Re: Petition No. 1588 – Endurant Energy petition for a declaratory ruling, pursuant to Connecticut General Statutes §4-176 and §16-50k, for the proposed construction, maintenance and operation of a 7.0-megawatt AC battery energy storage facility located at 22 Deerfield Road, Windsor, Connecticut, and associated electrical interconnection.

Enclosed for filing with the Connecticut Siting Council (“Council”) are Endurant Energy’s responses to the Connecticut Siting Council’s October 2, 2023 interrogatories.

Endurant Energy
Docket No. 1588

Interrogatory CSC 11

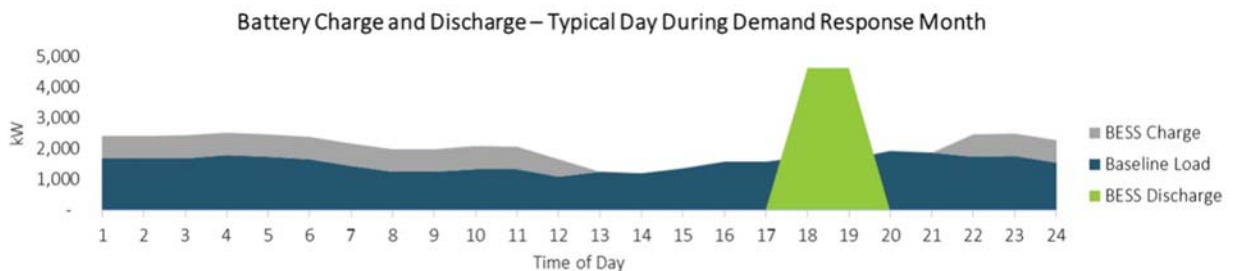
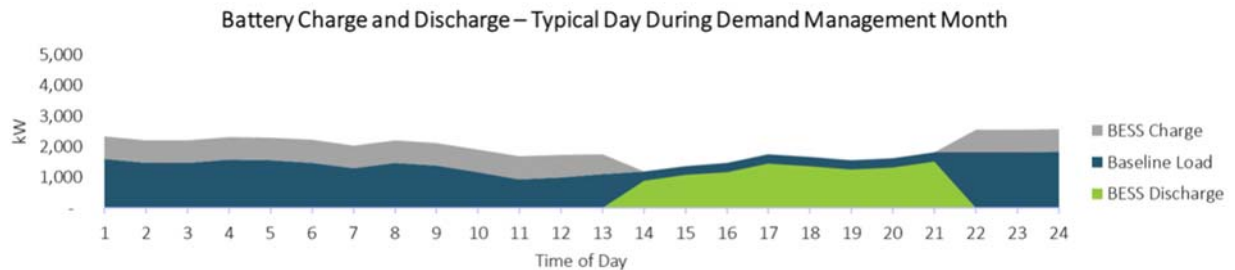
Q-CSC 11: What is the approximate percentage of Taylor & Fenn's annual electric load that would be served by the BESF?

A-CSC 11: Because this is an energy storage system and not an energy generation system, when the BESF serves Taylor & Fenn, it will not 'off-set' a specific portion of Taylor & Fenn's overall load, but instead will 'shift' the load required to lower-priced 'off-peak' times from expensive peak times (when the battery will be discharged). This load shifting, or management, will occur year-round. See Demand Management graph below. During the summer months, from June 1 through September 31, the battery will be participating in the Energy Storage Solutions Program. Again, it will charge during off-peak hours, but during the program's Performance Season, it will discharge as requested by the Program Administrators. See Demand Response graph below.

In terms of approximate percentages, the total annual consumption of the site with the battery is expected to be around 3,620 MWh, and the load that the battery will manage will be 900 MWh - approximately 25% served.
